Panel Report

Melton Planning Scheme Amendment C173

**Melton Landscapes - Significant Landscape Features
Strategy 2016**

30 April 2018

Figure 4 Mt Kororoit SLO

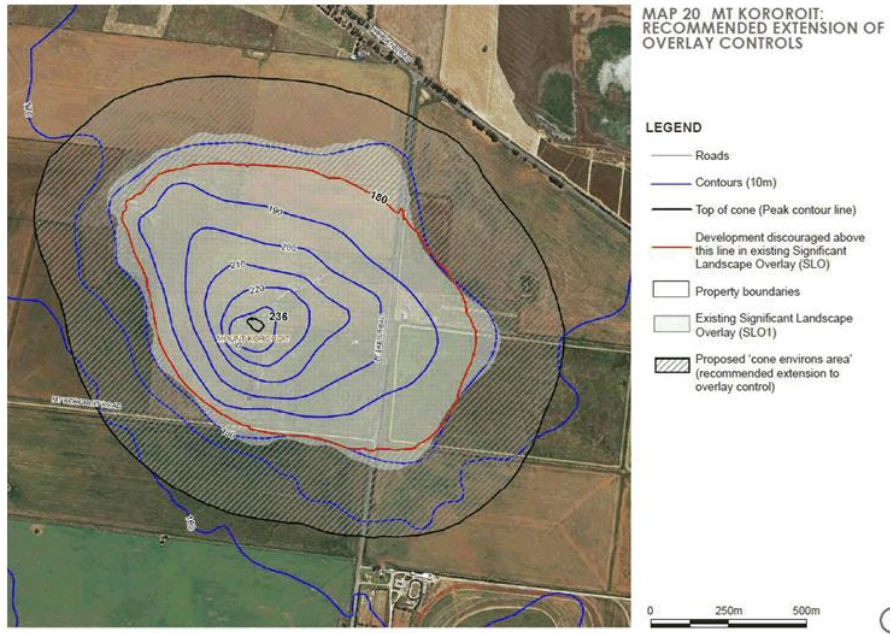
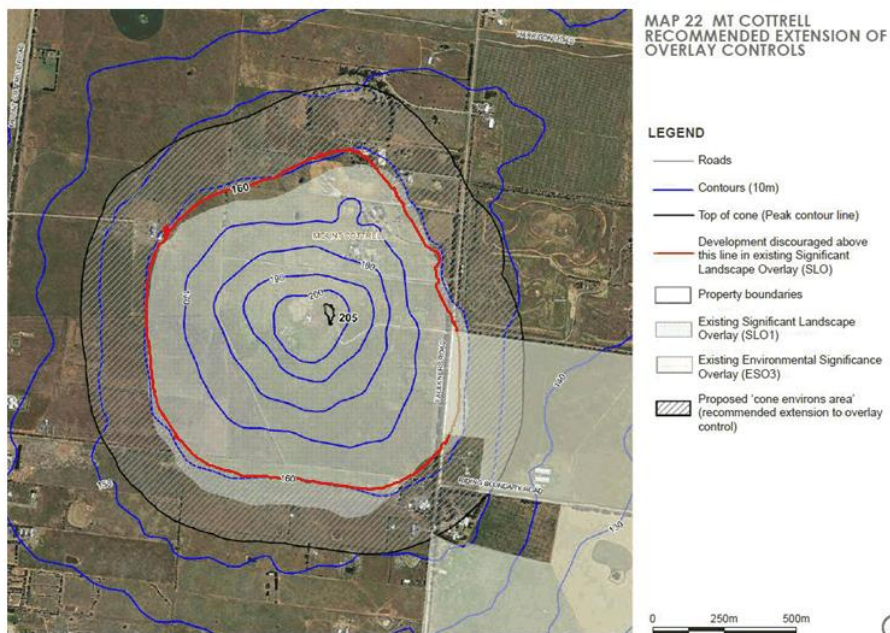
Council provided further clarity to the SLO mapping, in response to a Panel Direction. This Direction noted there were two different reference points (for example, for Mt Cottrell it refers to both the 160 metre contour and the existing SLO boundary) in the SLF Strategy from which the cone environs area was to be based. Figures 2, 3 and 4 indicate these are not the same. Council advised:

Mr Spehar questioned the reference point for the SLO boundary mapping for Mt Cottrell. He noted that, either the current SLO1 is mapped incorrectly as it extends beyond the relevant contour (that is, 160 metres for Mt Cottrell) or it includes a buffer already and there is no need for an extended cone environs area. If the former were true, then the cone environs areas would be reduced in size and not affect his father's property. This led to the Panel issuing a further Direction. Council's response is provided in Chapter 1.2.

The point Mr Spehar raised is important and has identified what could be a potential mapping anomaly. Council, however, did not consider there was an error and referred to the imprecise nature of the mapping at the time of the new format planning scheme when the SLO was introduced and has confirmed the mapping was always intended to refer to the relevant contour level as a basis for mapping the cone environs area.

The Panel has supported drafting improvements to some of the planning controls. Prior to approval of the Amendment, Council should ensure the mapping of the SLO that reflects the cone environs area is based upon the relevant contour for Mt Cottrell and Mt Kororoit.

- As discussed at the Panel hearing, the existing SLO mapping was understood to reflect the relevant contour. However, with the benefit of modern LIDAR data, it has become apparent that the existing SLO area does not correspond with the actual AHD contours (Mt Kororoit 180m; Mt Cottrell 160m).
- Reference in the SLF Strategy to distances measured ‘from the base of the cone area (i.e. existing SLO Boundary)’ (Figure 1), and ‘from the core cone area (i.e. existing SLO boundary)’ (Figure 2) were intended as references to the actual AHD contour of the base of the cones (Mt Kororoit 180m; Mt Cottrell 160m).
- The proposed extent of the SLO is calculated using the formula set out in Figures 1 and 2 of the SLF Strategy. The relevant extent is measured from the relevant AHD contour (Mt Kororoit 180m; Mt Cottrell 160m).

Council advised the red line on Figures 2, 3 and 4 represent the relevant contour as derived from ‘best available’ LIDAR data. Council confirmed the reference to “existing SLO boundary” is not accurate.

Figure 6 Mt Atkinson SLO

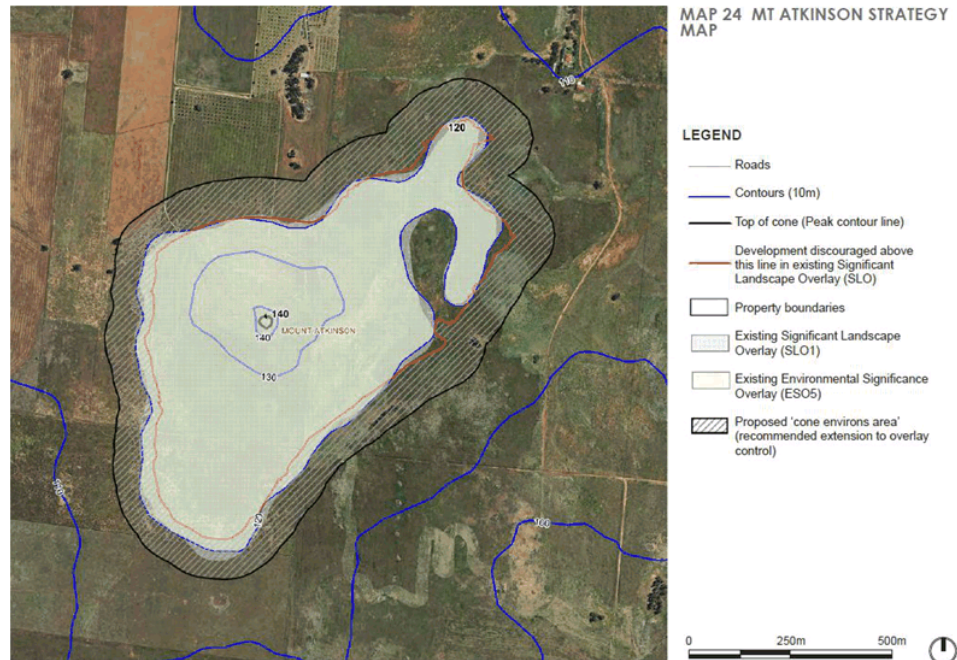
Council advised the Panel prior to the Hearing that it sought to abandon the proposed SLO extension for Mount Atkinson as it:

... has considered the Mt Atkinson related submissions in light of the approved Precinct Structure Plan (an event that occurred after finalisation of the Amendment documentation and at a time when the Amendment was too advanced to change the documentation). In the circumstances Council advises the Panel that it does not intend to peruse at Panel the mapping changes to the Significant Landscape Overlay for Mt Atkinson.

Council now proposes that the existing mapping of the Significant Landscape Overlay continue to apply to Mt Atkinson. This is outside of the approved limits of residential development and ensures consistency between the Precinct Structure Plan objectives and the application of the SLO.¹

The Panel supports the deletion of the Mount Atkinson SLO mapping from the Amendment as it would have applied a control that was inconsistent with the approved future urban land use and form. This report therefore considers the balance of the Amendment.

- 1. Abandon the proposed extension of the Significant Landscape Overlay at Mt Atkinson.**

Figure 8 Council owned land at Mt Cottrell

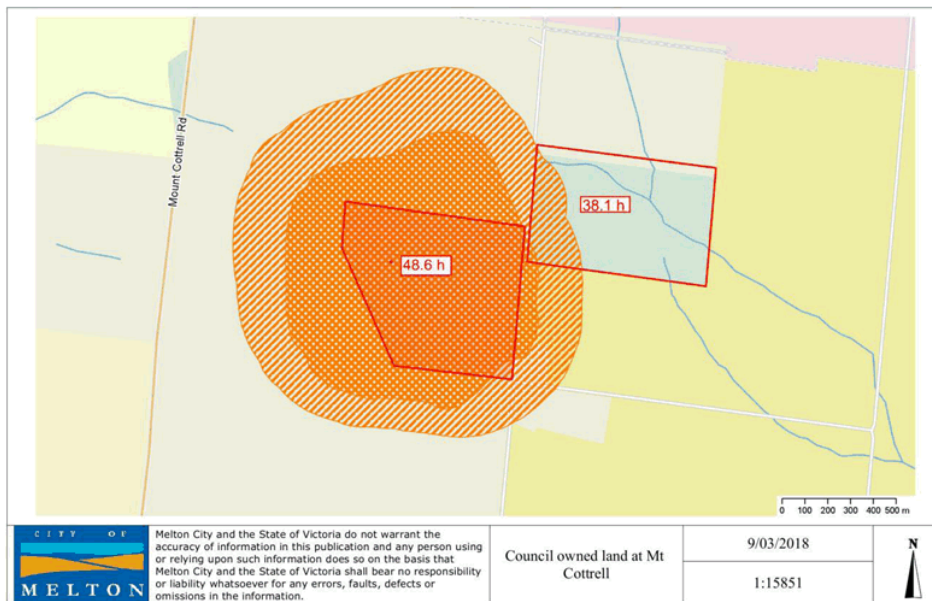
- *Confirm what land Council owns at Mt Cottrell.*

- Council owns land identified in Figure 8 at Mt Cottrell.
- Council was unable to find any materials that supported the use of the 160 metre contour for the SLO at Mt Cottrell. It submitted:
